Subject: Development Application No. SSD-93020230, 40 - 48 Redan Street, Mosman

For the reasons set out below, I object strongly to this development proposal. This application should not be approved.

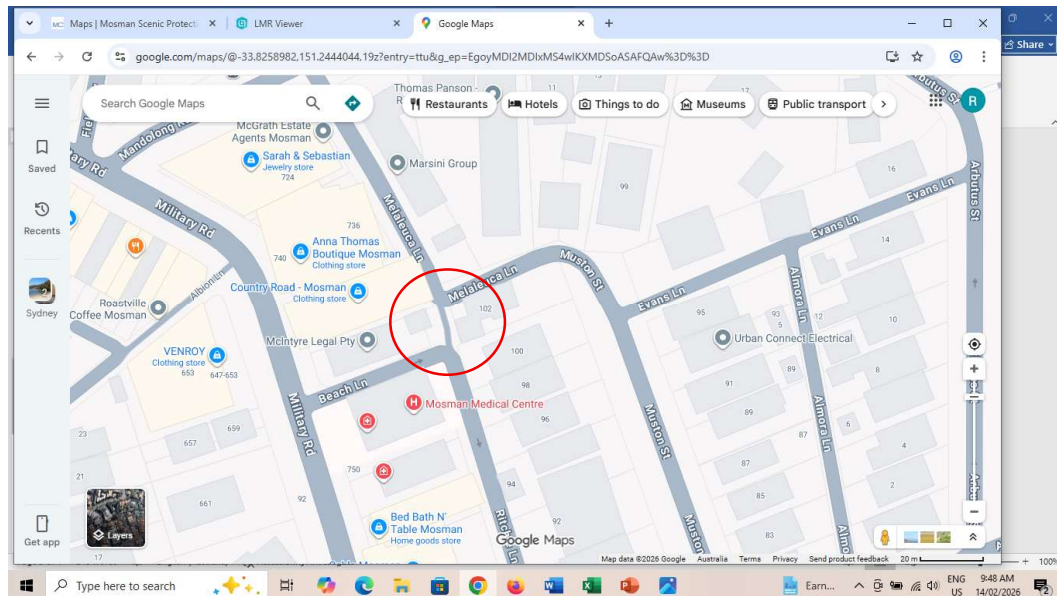
I note that the 'town centre' identified in the LMR policy is shown as extending east to the back of the premises occupied by the Country Road shop. However, it makes no sense to consider this point the end of a route to the town centre. There is no safe walking route from this point to either retail areas or a transport hub.

Immediately to the south of this corner of the mapped 'town centre' there is a narrow paved section of roadway incorporating a bike path. It does not provide a safe route for pedestrians walking between Melaleuca Lane and Beach Lane of Ritchie Lane. It is clear from the Google maps excerpt below that it is not a full vehicle/pedestrian route. On the map, it does not even merit a name.

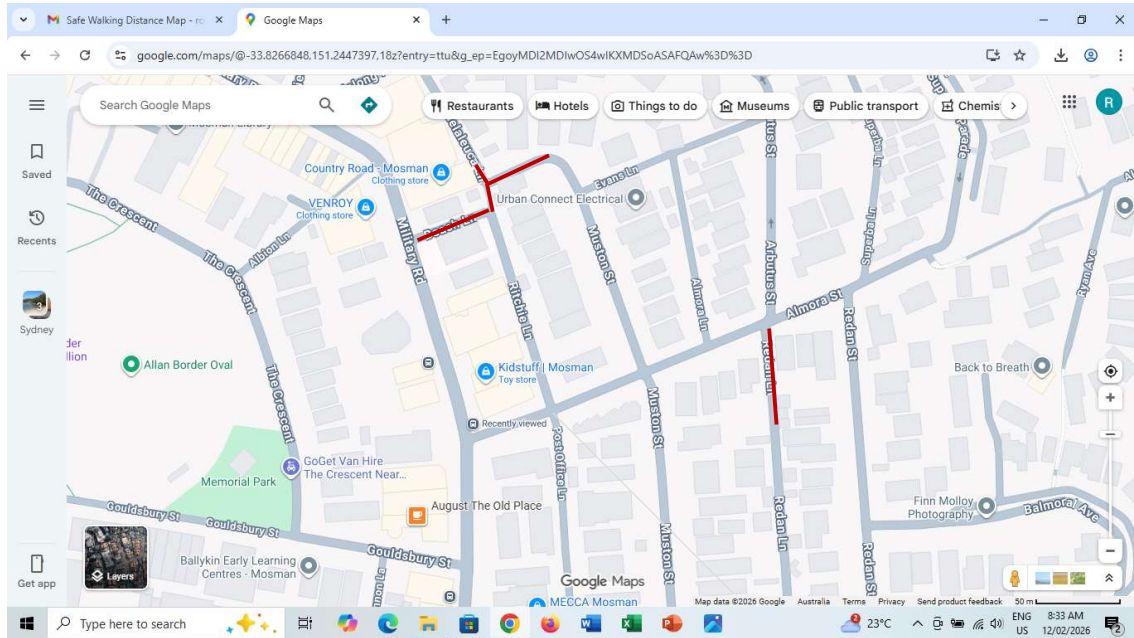
I note that Melaleuca Lane is identified in Section 6.7 of the Mosman DCP as part of a lane widening program intended to provide adequate vehicular and/or pedestrian access. The DCP states that 'when development is proposed on land affected by Council's lane widening program, Council will seek to have a portion of the land dedicated ... to Council for the purpose of widening the lane or accessway.' Melaleuca Lane requires widening for the safe passage of pedestrians, but there is no timetable for the work and no guarantee that it will occur in the future.

The Google maps excerpt below shows the lanes where it is not safe to walk between the proposed development site in Redan Street and the rear of the Country Road premises, and between that point and the actual Mosman village area.

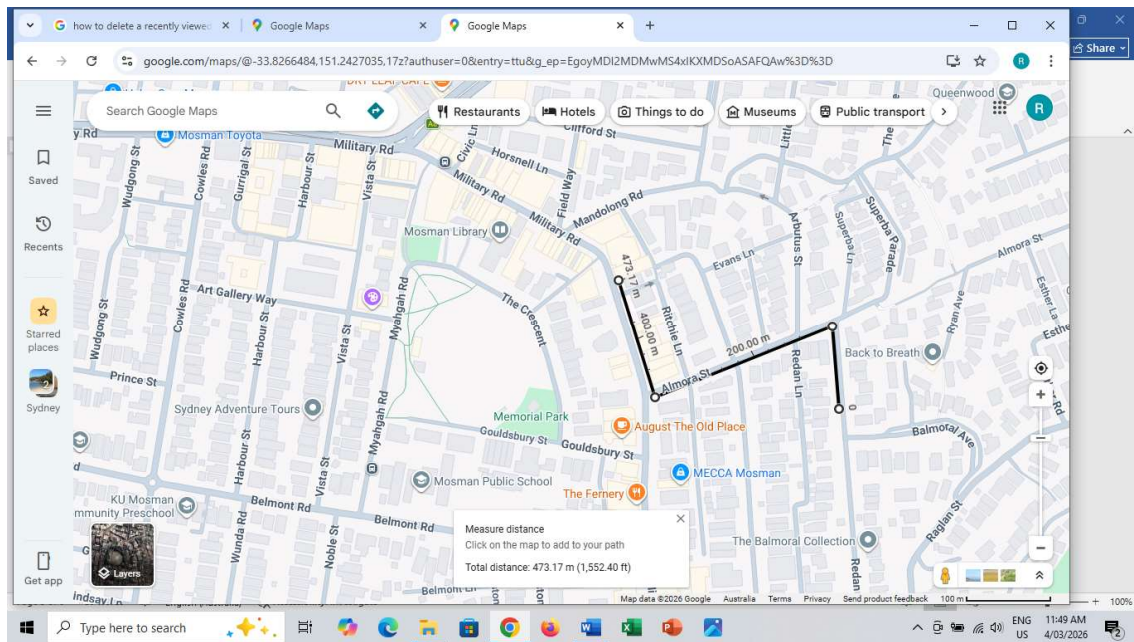
Using Google Maps, I have measured the shortest safe pedestrian route to the accessible corner of the 'town centre' from 48 Redan Street (the closest lot to the town centre). The route starts in Redan Street at the north east corner of the lot and proceeds along Redan Street to the corner of Upper Amora Street where it turns west. At the intersection with Military Road, it turns north via a marked pedestrian crossing and follows Military Road to the corner of the Country Road shop. The distance I measured is 473.17 metres.

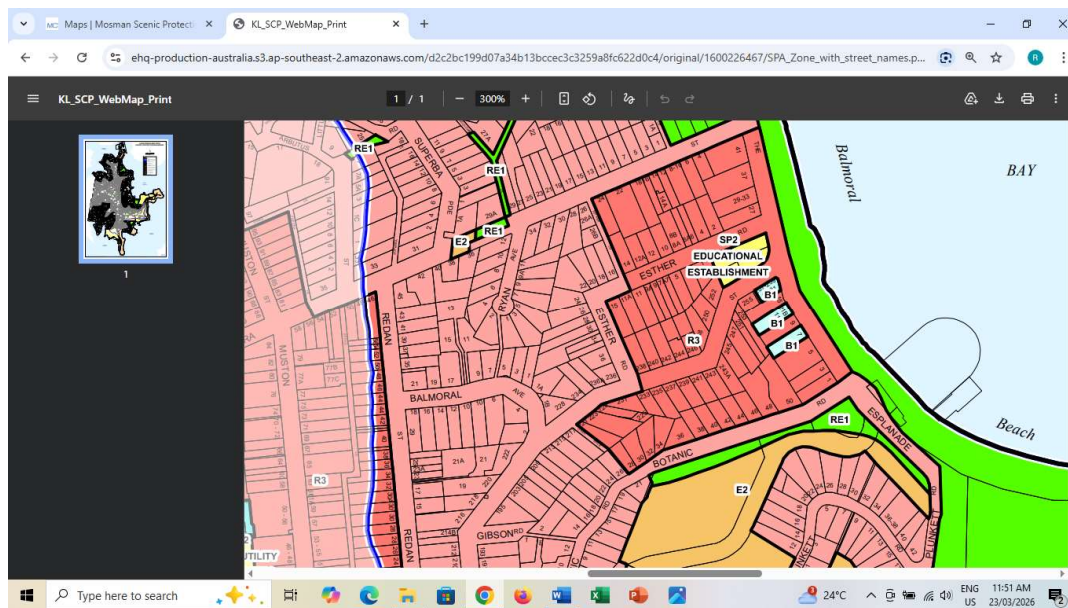
The proposal fails to respond appropriately or enhance the natural features or built environment of the area. Its bulk, height and scale would visually dominate the streetscape and disrupt the harmony of the views from the harbour and foreshores. It is completely unsuitable for the proposed location.
